## Schwartzwalder Mine Revised AM-06

**Subject:** Response to Third Adequacy Review  
Application Amendment #6  
Mine Land Reclamation Permit M-1977-300, Schwartzwalder Mine, Golden, Colorado

FIGURE F-1  
RECLAMATION PLAN MAP

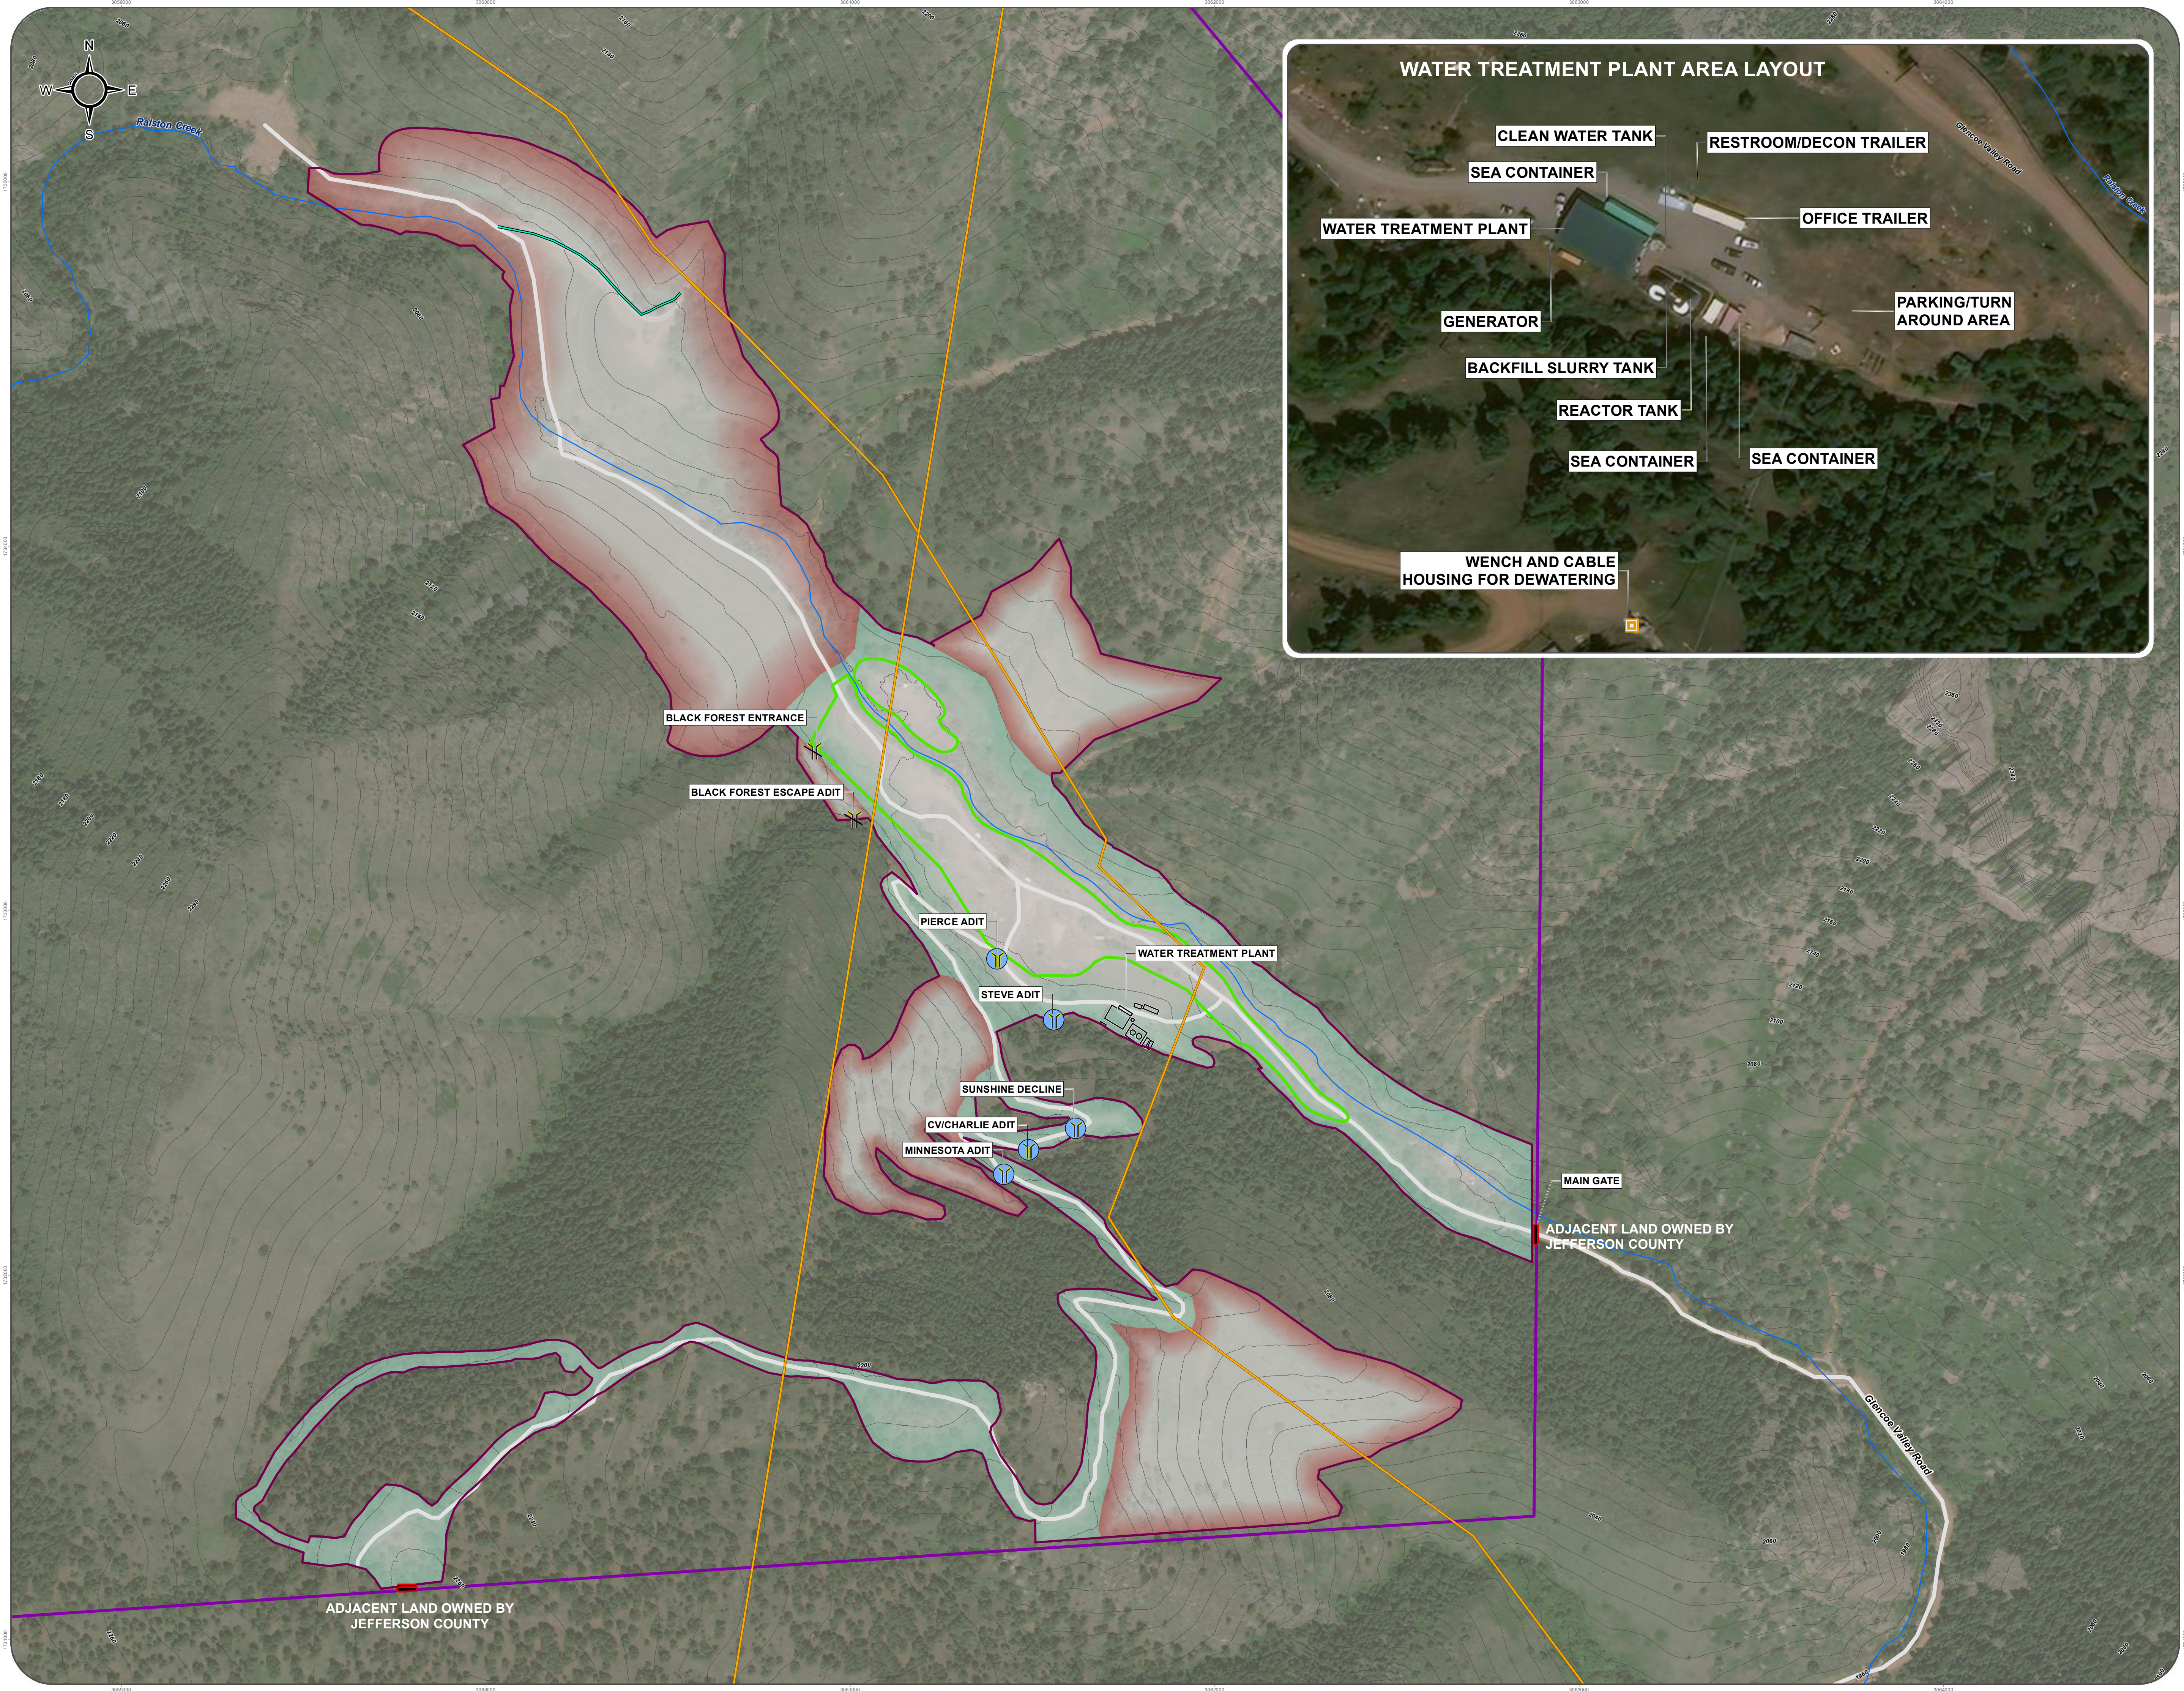
9	<p>Exhibit F–Reclamation Plan Map (Rule 6.4.6):</p> <p>The Division has the following comments on Figure F-1 Reclamation Plan Map:</p> <ol style="list-style-type: none"> <li>Please identify the entire disturbed area to be revegetated. The area currently identified as “Anticipated Planting Area (12.5 acres)” does not appear to include the entire area in the valley that has been disturbed, including the area located north of the creek (currently used for storage). Additionally, the area shown is actually closer to 6-7 acres in size rather than 12.5 acres. Furthermore, this area overlaps the creek in some areas, indicating portions of the creek channel will be revegetated for reclamation. Is this accurate?</li> <li>Please identify the approximate areas to receive each of the seed/plant mixtures proposed in Tables E-1 and E-2. Please be sure these areas correlate with the acreages provided in Exhibit E.</li> <li>The final alignment of Glencoe Valley Road between the eastern site access and the upgradient cutoff wall is not visible on this figure. Please show the approximate alignment of this road for final reclamation.</li> <li>Please remove the upgradient cutoff wall and bypass pipeline from this figure. As mentioned above, the Division cannot approve leaving these structures in place for final reclamation until the operator has demonstrated that leaving these structures is authorized by the USACE/USFWS permitting for the site.</li> </ol>	<ol style="list-style-type: none"> <li>Figure F-1 has been revised to identify the entire disturbed area that will be replanted / revegetated. All of the planting (grass seed, trees, and shrubs) is expected to occur in the disturbed area shown on this figure. Please note, this area includes the storage space north of the creek and excludes Ralston Creek.</li> <li>This area is identified in the legend of Figure F-1 as “Disturbed Area to be Revegetated / Replanted”.</li> <li>The final alignment of the Glencoe Valley Road is shown in Figure F-1. The legend symbology has been revised for clarity.</li> <li>In the interest of advancing the review and approval of AM-06 before the 1-year deadline, the bypass pipeline and cut off wall have been removed from this figure. The language in AM-06 is other Exhibits have also been updated to indicate the removal of these temporary features. However, CLL does view the bridge as beneficial to the site, and will work with DRMS, USACE, and USFW to obtain the necessary permit approvals to maintain this feature.</li> </ol>

Project/Drawing Information		
Project Name	Schwartzwalder Mine	
Project Number	EUS22C000174	
Project Location	Golden, Colorado	
Drawing Name		
FIGURE F-2 Alluvial Valley Reclamation Plan Map, Schwartzwalder Mine		
Drawing Number

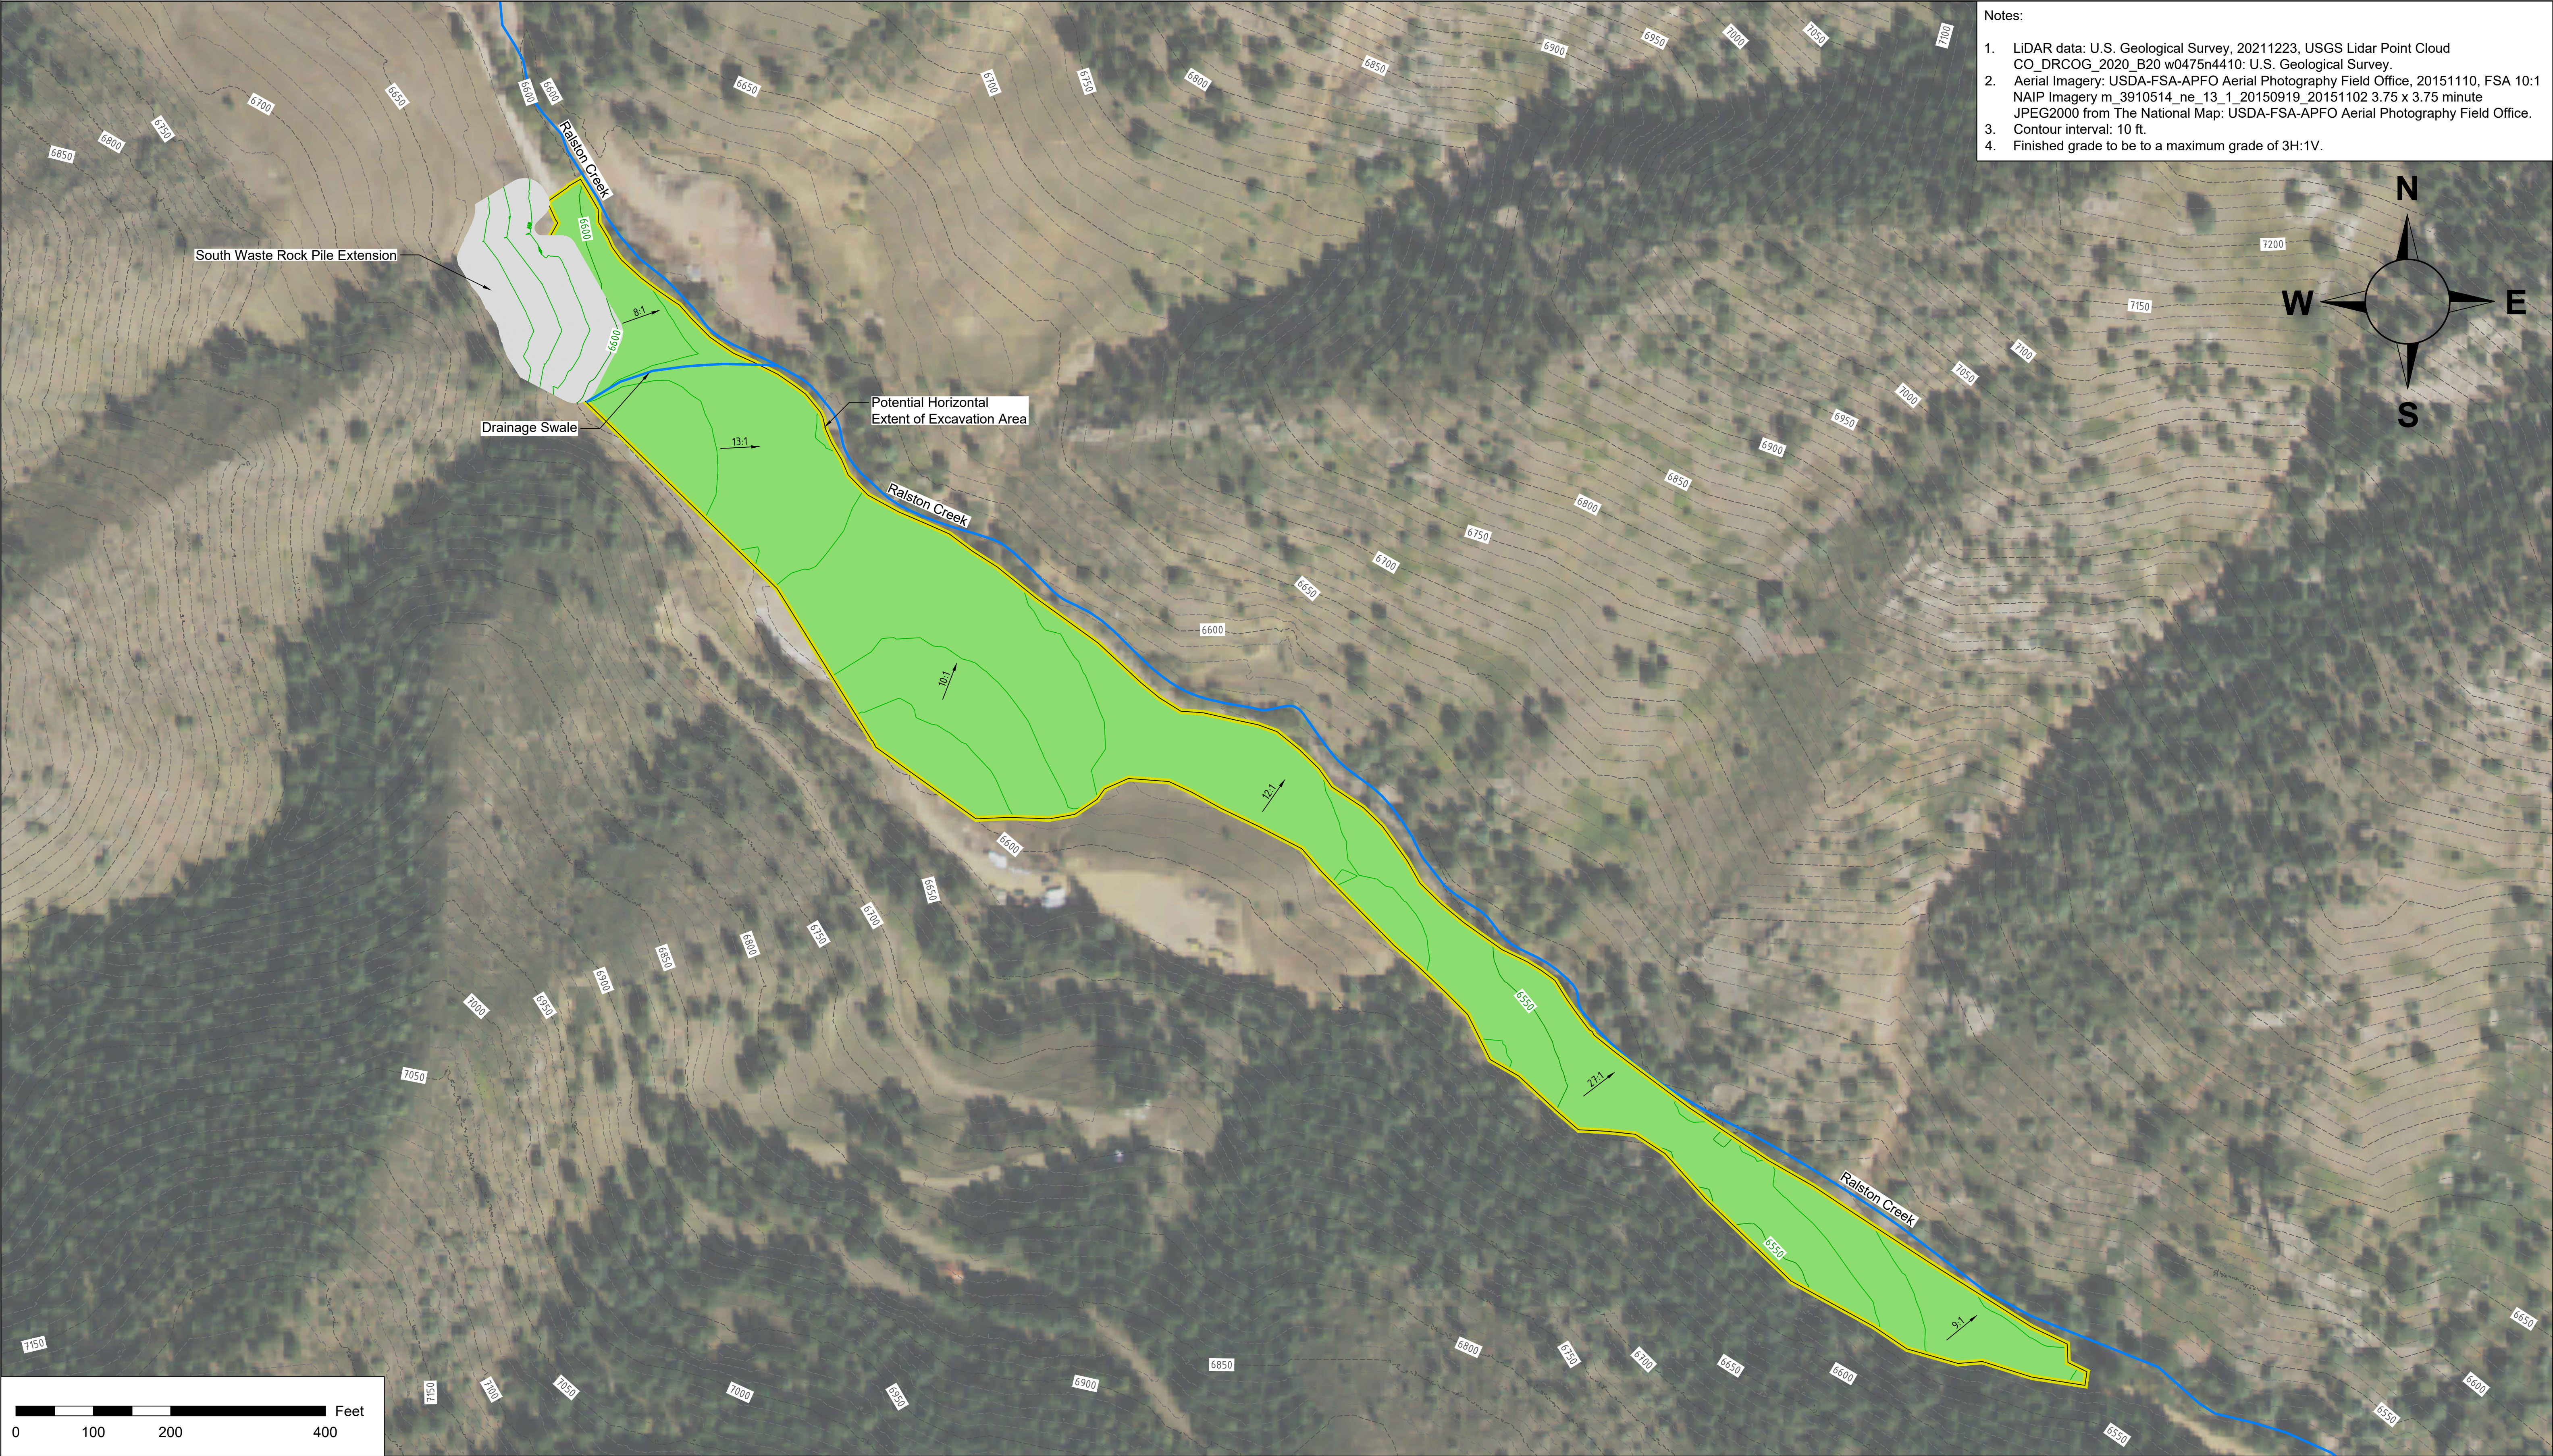
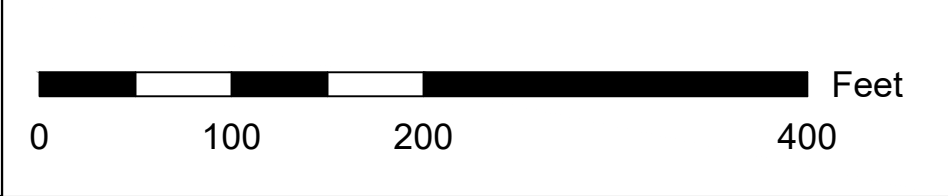
10	As previously requested, please provide a separate reclamation plan map depicting a detailed grading plan for the valley floor. This map should show how the valley floor will be reconfigured to establish positive drainage to the creek, and any structures proposed to remain in the valley for final reclamation.	Revised as requested. Additional text has been added to Exhibit E to describe the alluvial valley reclamation and a new figure has been added to Exhibit F (Figure F-2) to illustrate the proposed plan.
11	Exhibit L–Reclamation Costs (Rule 6.4.12):

**FIGURE 7-2**

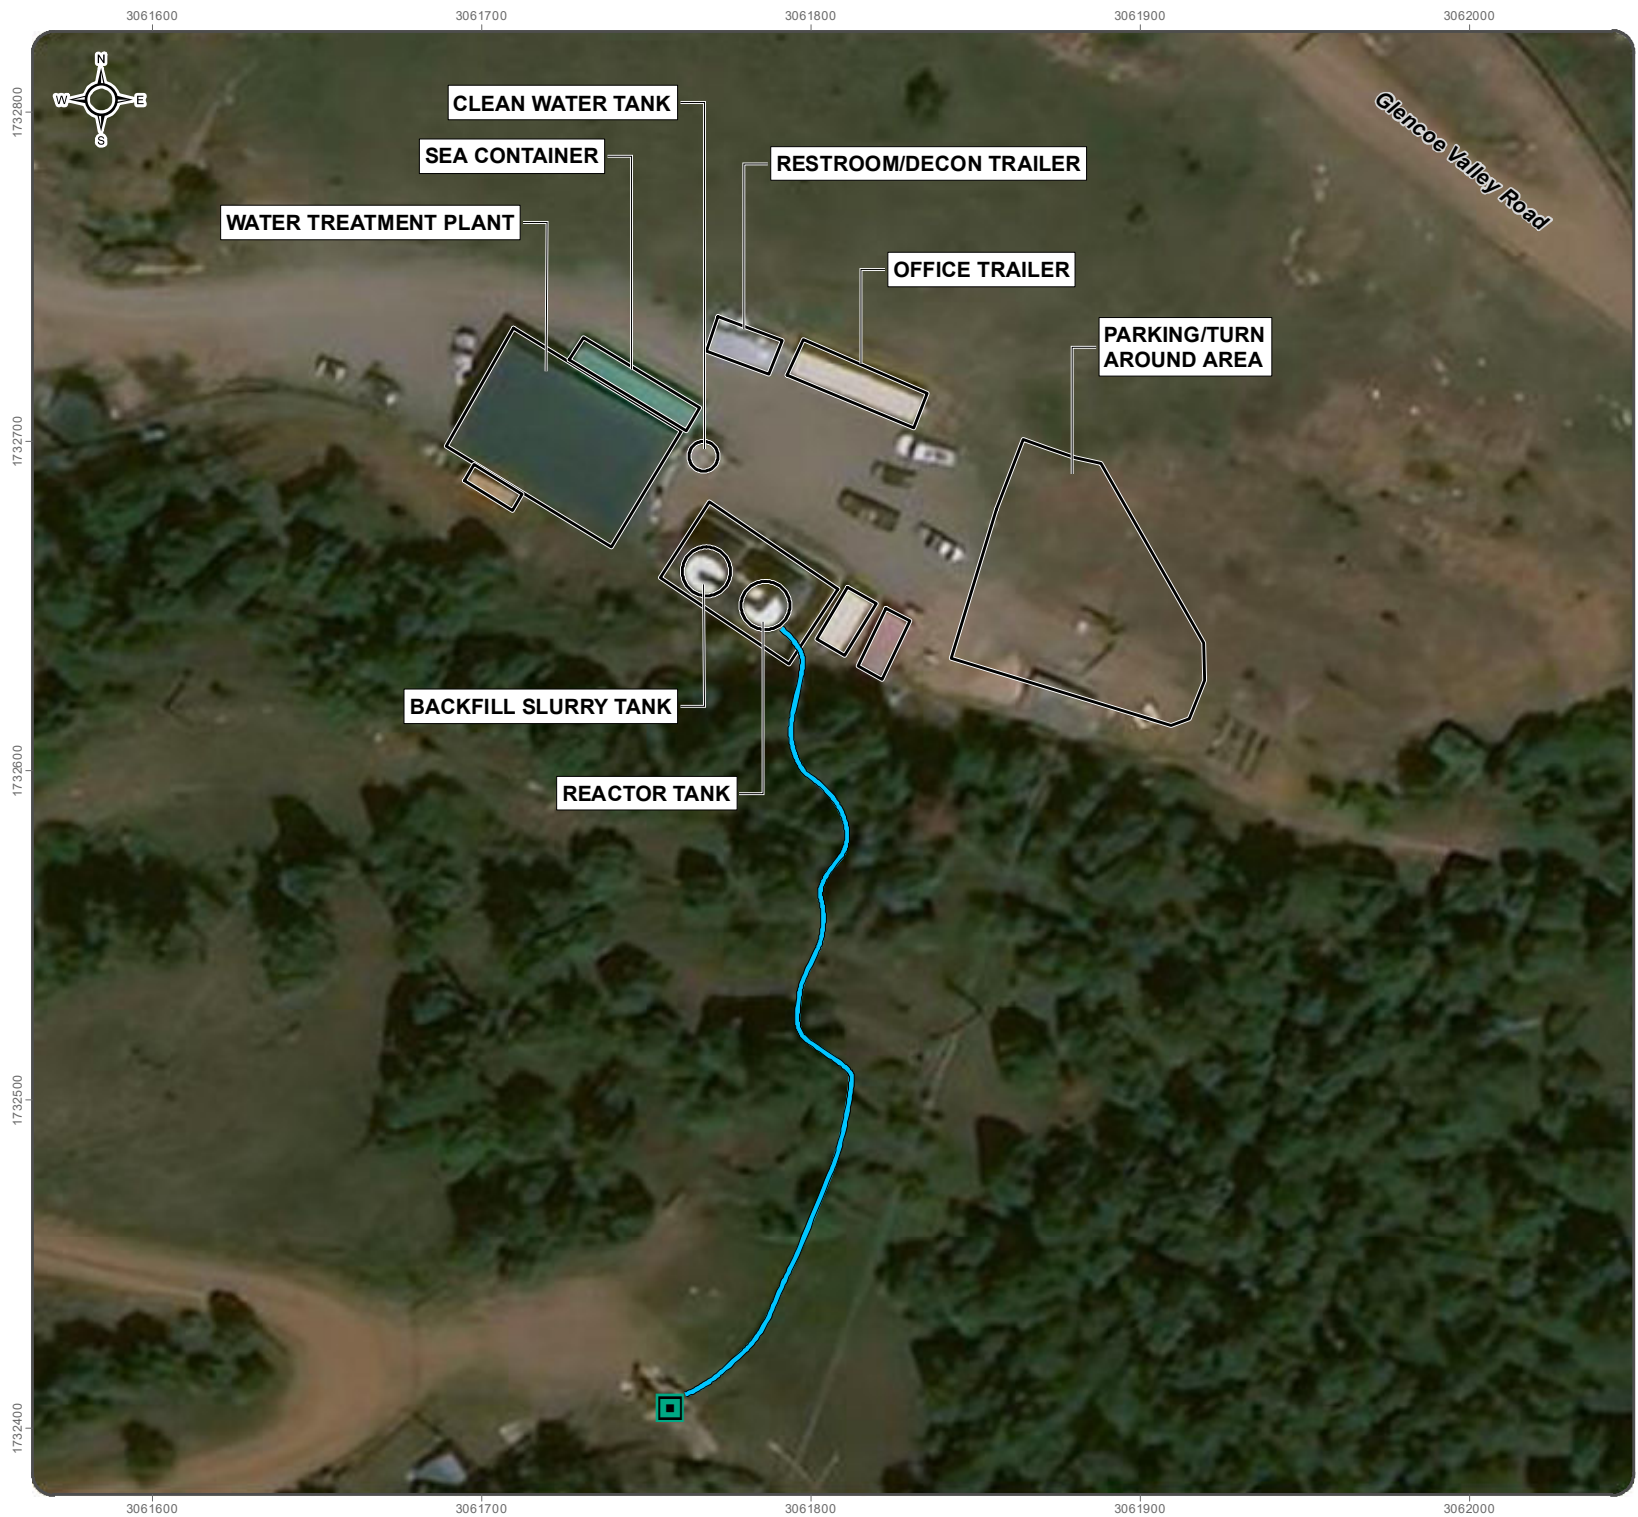
15	<p>The Division has the following comments on Figure 7-2-Mesa Water Treatment Plant Building Layout:</p> <p>a. It is the Division’s understanding that an above-ground pipeline runs from the new dewatering pump in the Jeffrey Air Shaft to the water treatment facility on the mesa. Please be sure this figure shows all components of the facility, including any pipelines.</p>	<p>a. The figure has been revised to show the pipeline.</p>
16	<p><b><u>Additional Item(s):</u></b></p> <p>Please remember that, pursuant to Rule 1.6.2(1)(c), any changes or additions to the application on file in our office must also be reflected in the public review copy which was placed with the County Clerk and Recorder. Pursuant to Rule 6.4.18, you must provide our office with an affidavit or receipt indicating the date this was done. This “proof” should be submitted with your adequacy response.</p>	<p>Thank you. Comment noted.</p>
